**ARC REVIEW CODE:** R2108021

**Name of Proposal:** Bowen Road Logistics Center DRI #3376

**Review Type:** DRI

**BOWEN ROAD LOGISTICS CENTER DRI**  
**City of Palmetto**  
**Natural Resources Group Review Comments**

DRI SITE PLAN

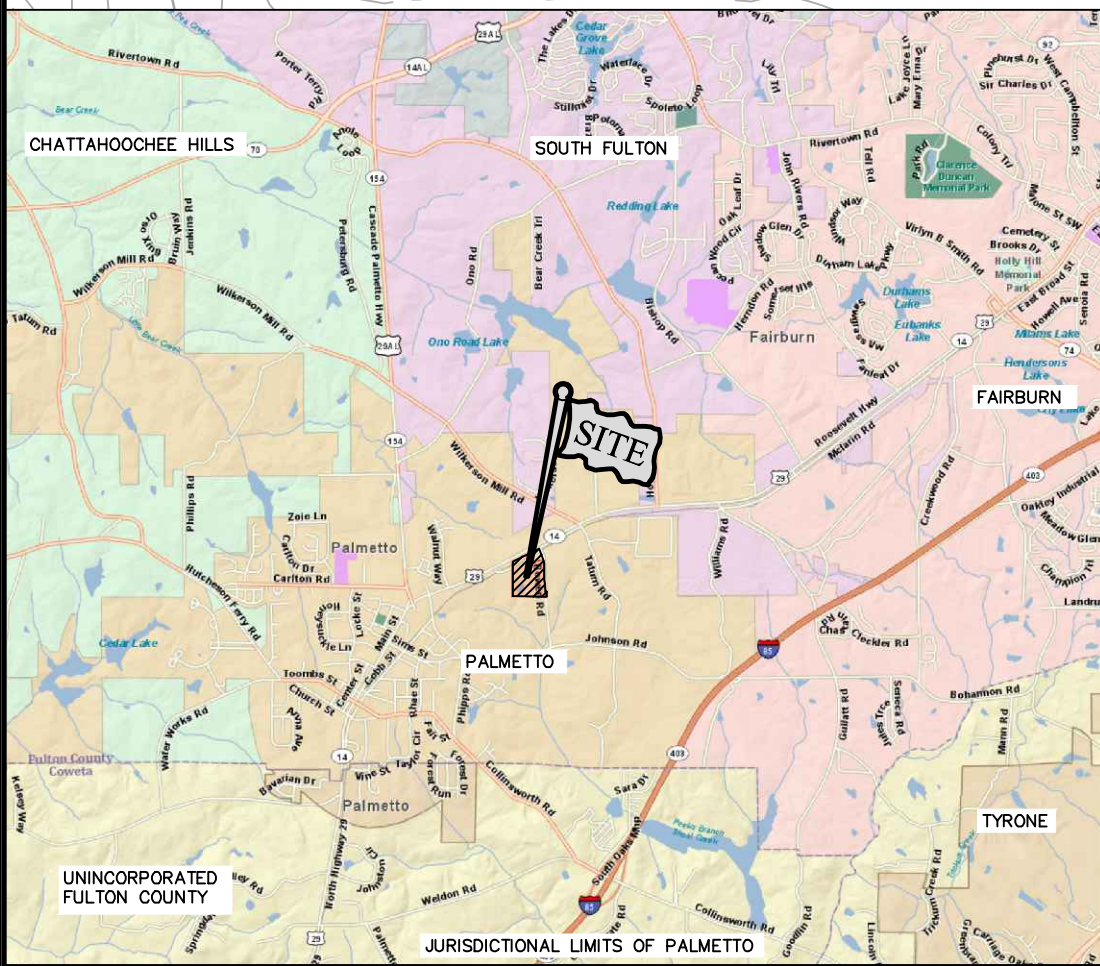
The USGS coverage for the project area shows an existing pond but no streams on or near the project property. The submitted site plan shows a stream and wetlands areas on the west side of the property. Although not identified, lines are shown on both sides of the portion of the stream below the large wetland area shown on the submitted site plan. The lines appear to be about 75 feet from the center line of the stream on both sides and may represent the total depth of the 50-foot undisturbed buffer and additional 25-foot impervious surface setback required under City of Palmetto Stream Buffer Ordinance. The buffer does not extend past the large wetland area, where the proposed development extends close to the stream. Development also intrudes into the indicated wetlands.

The City of Palmetto Stream Buffer Ordinance may apply to the entire mapped stream. The Georgia 25-foot State Erosion and Sedimentation Act buffer also applies to the entire stream and wetlands but is not shown on the plans. The development activity shown near the mapped stream and in the mapped wetland area may require variances. Any unmapped streams may also be subject to the City buffer ordinance and all unmapped waters of the state may be subject to the 25-foot State Erosion and Sedimentation Act buffer.
